- Change of production location
- Change of packaging label

Product Change Notification					Change production location of div. types		
owner	creation date	release date	released by	change order	rev	page	D10-101-490
sariogar	13.07.2026	13.07.2026	gassmael		B	1 of 2

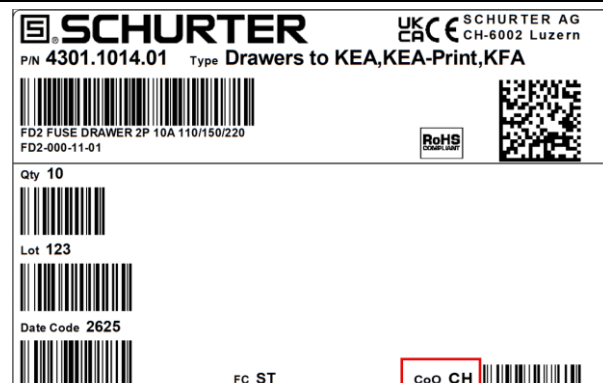
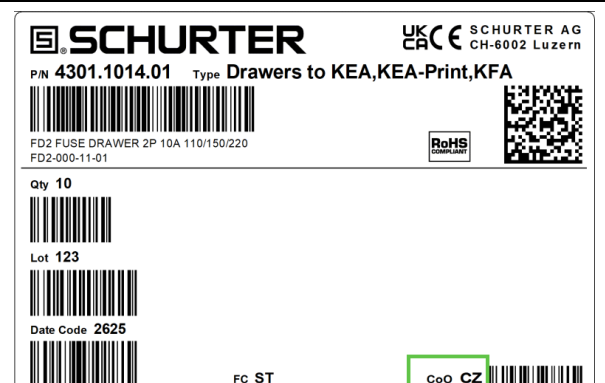
Current Packaging label country of origin Switzerland	New Packaging label production site Czech Republic

- ☐ Form
- ☐ Fit
- ☐ Function
- ☒ Manufacturing Note new manufacturing site
- ☒ Label No action required; inform incoming inspection about changes on label
- ☐ Packaging
